PLANNING UNIT REPORT
DEPARTMENT OF PLANNING AND DEVELOPMENT
September 13, 2006

DEMOLITION PERMIT – 5721-5901 ODANA ROAD:

TO: Plan Commission
FROM: Timothy Sobota, Transit Planner, Metro Transit
SUBJECT: 5901 Odana Road – “Smart Motors”

DATE: August 1, 2006
TO: Plan Commission
FROM: Larry D. Nelson, P.E., City Engineer
SUBJECT: 5901 Odana Road Demolition

Atch: Exhibit page “SP-2 Proposed Site and Utility Plan” [7/11/2006], notated with approximate amenity locations

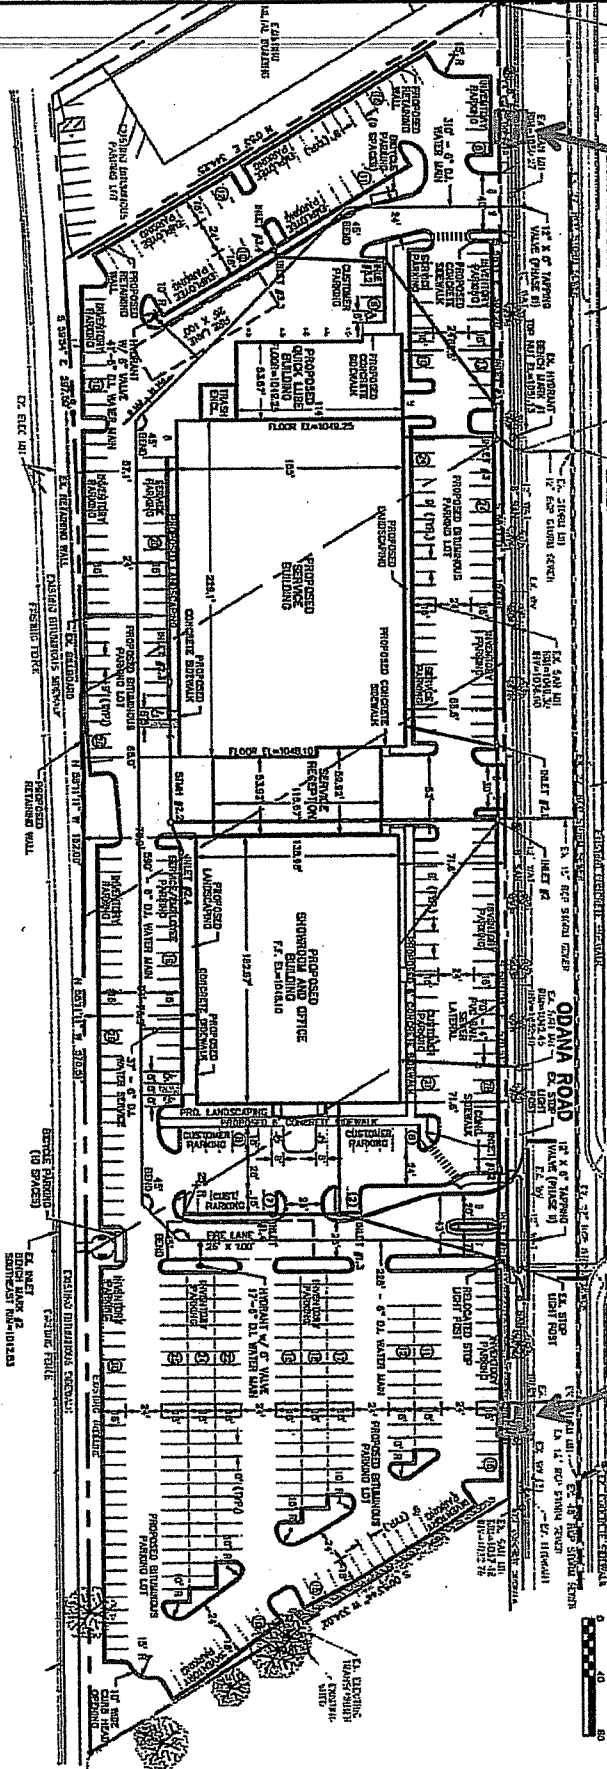
1. The applicant shall install a concrete passenger boarding pad on the south side of Odana Road, approximately eighty feet east of crosswalk marking along the east side of the Tokay Boulevard intersection. The concrete pad shall occupy the full distance of the terrace, measure 6 feet in width parallel to the street, and lie flush between the sidewalk and the top of curb.

2. The applicant shall install a concrete passenger boarding pad on the south side of Odana Road, approximately twenty-five feet west of western-most driveway apron serving the area marked employee parking. The concrete pad shall occupy the full distance of the terrace, measure 6 feet in width parallel to the street, and lie flush between the sidewalk and the top of curb.

3. The applicant shall include the location of these passenger amenities on the final documents filed with their permit application so that Metro Transit may review and approve the design.
